# 2022/4203/P - 33 Theobald's Road, WC1X 8SP

<b>Delegated Report</b>		<b>Analysis sheet</b>		<b>Expiry Date:</b>	<b>27/12/2022</b>
<b>(Members Briefing)</b>		N/A		<b>Consultation Expiry Date:</b>	<b>18/12/2022</b>
<b>Officer</b>			<b>Application Number(s)</b>		
Miriam Baptist			2022/4203/P		
<b>Application Address</b>			<b>Drawing Numbers</b>		
33 Theobald's Road London WC1X 8SP			See Draft Decision Notice		
<b>PO 3/4</b>	<b>Area Team Signature</b>	<b>C&amp;UD</b>	<b>Authorised Officer Signature</b>		
<b>Proposal(s)</b>					
Installation of extract flue on rear elevation and retention of two existing AC units on single storey rear extension.					
<b>Recommendation(s):</b>		Grant planning permission			
<b>Application Type:</b>		Full Planning Application

Installation of extract flue on rear elevation and retention of existing AC units on single storey rear extension.

*Original proposal flue termination (left) and revised proposal (rev A) flue termination (right)*

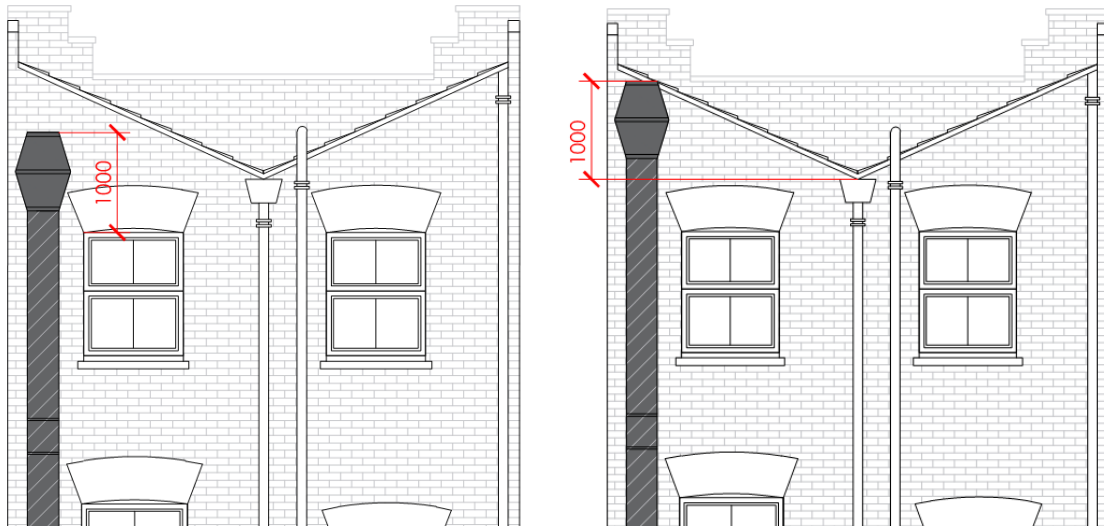
2.2 Revisions: The height of the flue has been revised as per the images below:
